CONSTRUCTION VALUE ENGINEERNG CONCEPT PROPOSAL
MISSOURI DEPARTMENT OF TRANSPORTATION

Contract ID 090123-611

Job No. J6S2027

VECP 09-63

Proposed change to plan.

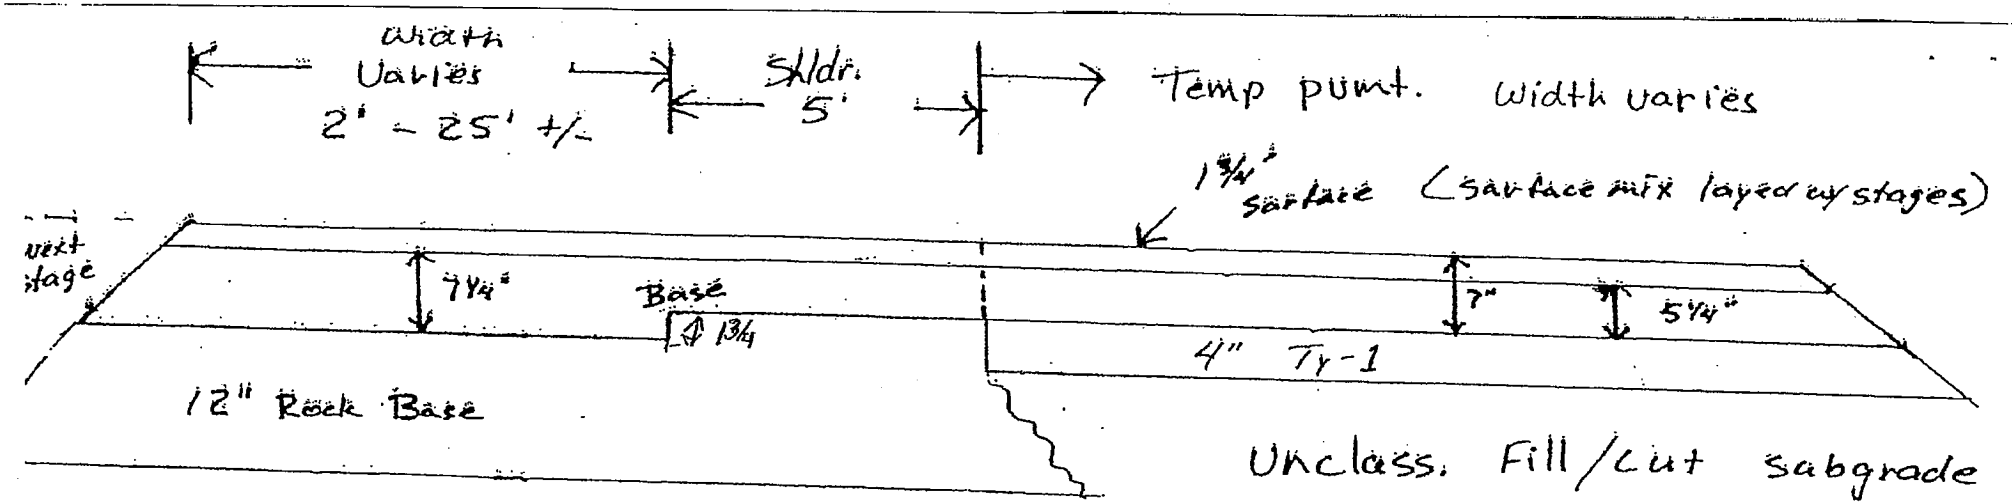
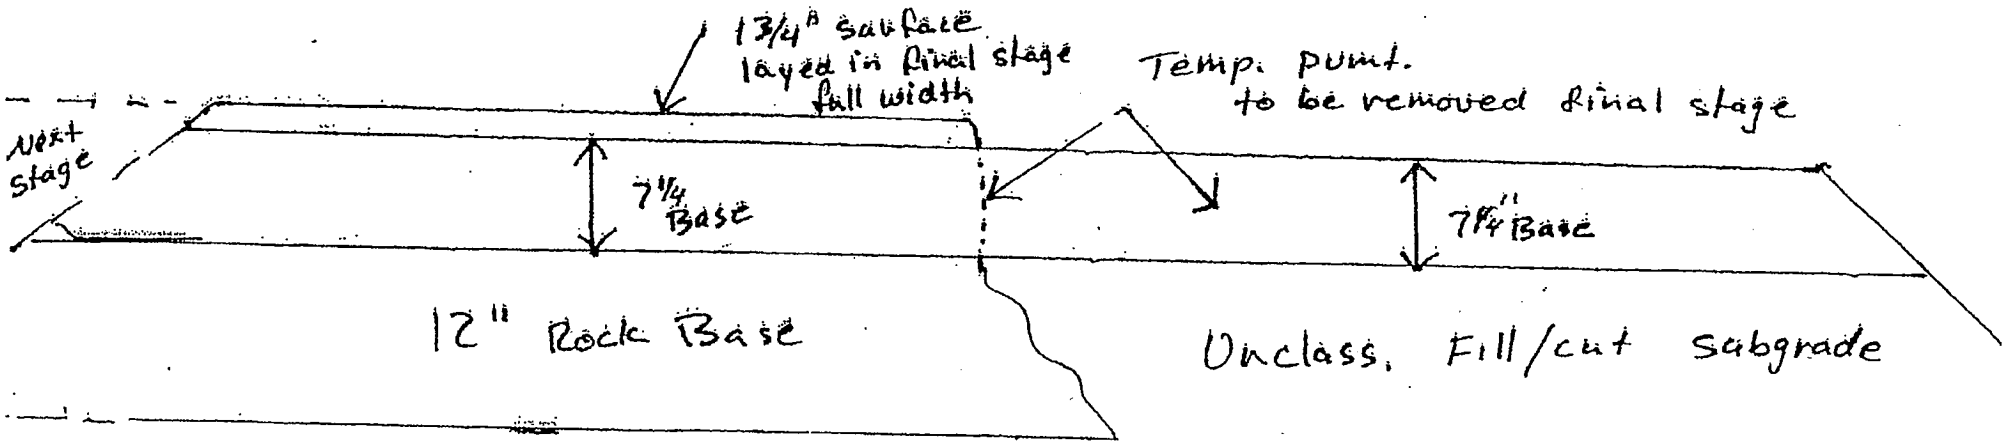
1. **Description of existing requirements and proposed change(s). Advantages/Disadvantages**
   Existing plans provide for 4 inches of Type 1 Base Rock beneath 7 inches of bituminous temporary pavement.

The temporary pavement will be placed on a stable rock fill base for a short duration and removed in a later stage. Because of the short duration of usage for the temporary pavement and the stability of the rock base used to build the roadway fill the elimination of the 4 inches of Type 1 base will not effect the service of the temporary pavement and provide a cost savings.

I have discussed this proposal with the project Manager and MoDOT District 6 Materials Dept and we feel that this method/product is Acceptable. The project Manager & I feel that this proposal meets more the criteria of a "Practical Design" in Lieu of a Value Engineering Proposal.

I AGREE THAT THIS SHOULD BE A PRACTICAL DESIGN VE. 75/25.

This VE is acceptable. The contractor will be responsible for the maintenance of the temporary pavement. Denis Glascock 8/10/2009
